May 23, 1996  
6710 -96-2136

Subject: Three Mile Island Nuclear Station, Unit 1 (TMI-1)  
Operating License No. DPR-50  
Docket No. 50-289  
Inservice Testing of ASME Code Class 1, 2, and 3 Pumps and Valves  
(IST) - Response to NRC Questions Regarding Code Relief for the  
Third Ten Year Interval

## RELIEF REQUEST NO. P 1 (REVISED)

FIGURE 1

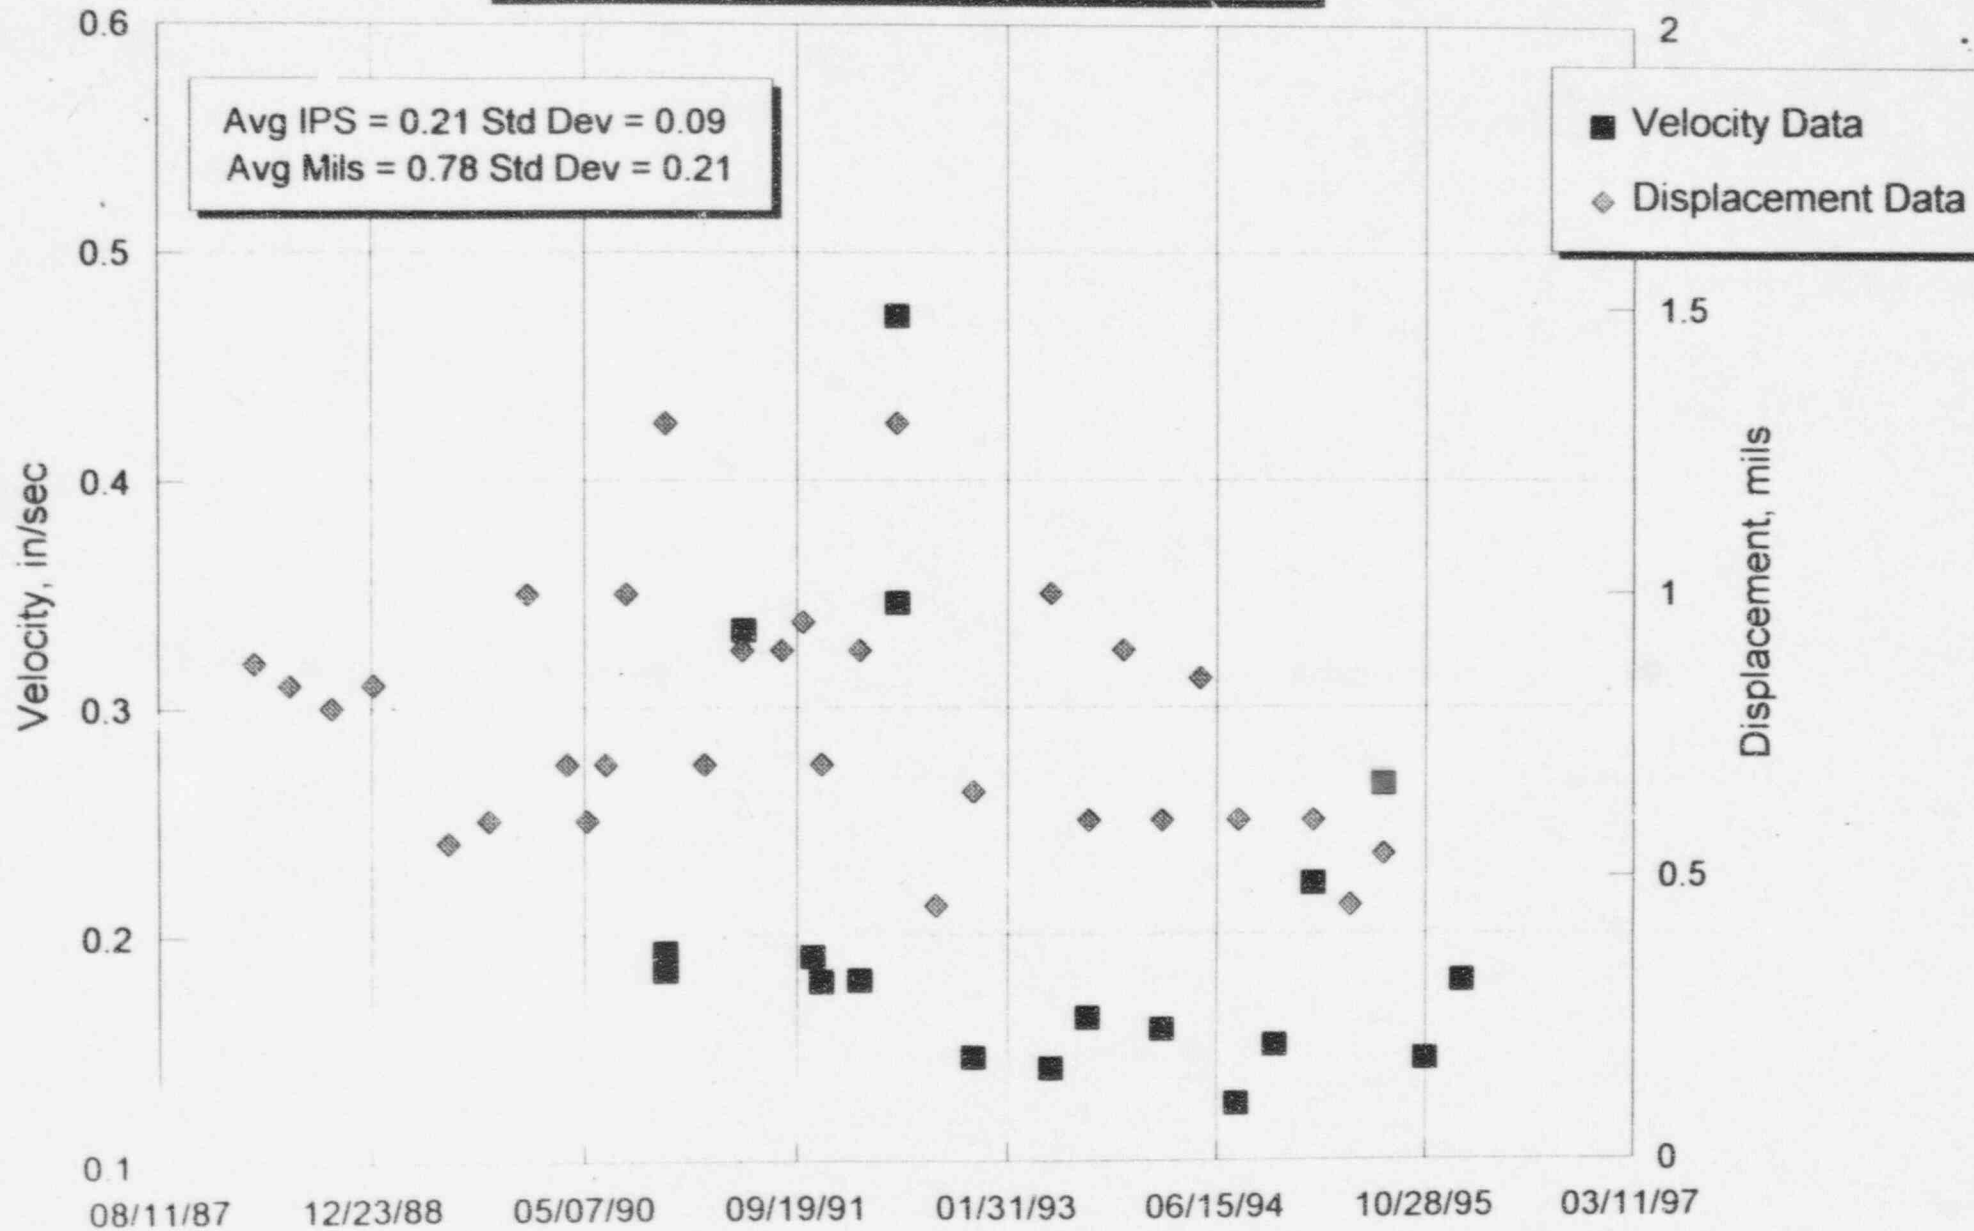
Relief is requested from OM-6, §6.1, "Acceptance Criteria" which requires doubling the test frequency until the cause is determined and corrected for vibration readings in the alert range (0.325 ips).

The alert range for DH-P1B will be raised to vibrations greater than 0.400 ips (vs greater than 0.325 ips) in the vertical direction. The alert range for the horizontal direction will remain at vibration levels greater than 0.325 ips.

Figures 1 and 2 show vibration data from tests of the DH Pumps (DH-P1A and DH-P1B, respectively) since 1987. Points shown represent the highest vertical overall amplitude since amplitudes in the vertical direction are higher than the horizontal vibration amplitudes. The vibration spectrum is essentially all at vane pass frequency with no 1X or 2X harmonics that could indicate pump problems. These data present a clear case for raising the allowable vibration levels for DH-P1B. Several attempts have been made to reduce the vibration levels for the Decay Heat Pumps, including pump motor alignment, strengthening the backfoot, and adding lead weights to the back end of the pump.

Based on the successful operating history of DH-P1B, no step changes or trends in vibration data as shown on Figure 1, extensive vibration analysis, shop testing, and vendor input, GPU Nuclear does not consider the vibration amplitudes of DH-P1B unacceptable. Replacing or modifying the pumps to reduce vibrations only to assure they do not occasionally exceed 0.325 ips could be unnecessary. Further, doubling the test frequency would result in running the pumps more often at low flow conditions and would provide no useful information. Therefore, this request to allow raising the alert range to greater than 0.400 ips (vs greater than 0.325 ips) is justified for DH-P1B.
